10/531,064

Office Action Summary	Application No. 10/531,064	Applicant(s) BAGLIONE, DANIEL	
	Examiner Gregory A. Wilson	Art Unit 3749

DETAILED ACTION

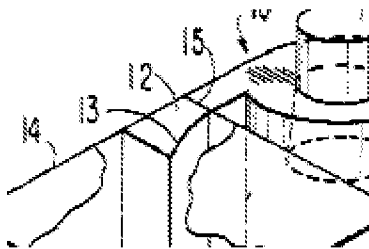
Examiner hereby acknowledges the applicants amendment to the drawings, submitted November 24, 2008 which shows a connection between the reaction chamber (1) and the separator (2) as indicated by the small line at the bottom of Figure 2, linking the two structures together. The objection to the drawings submitted in Office Action dated 3/3/09 is hereby withdrawn.
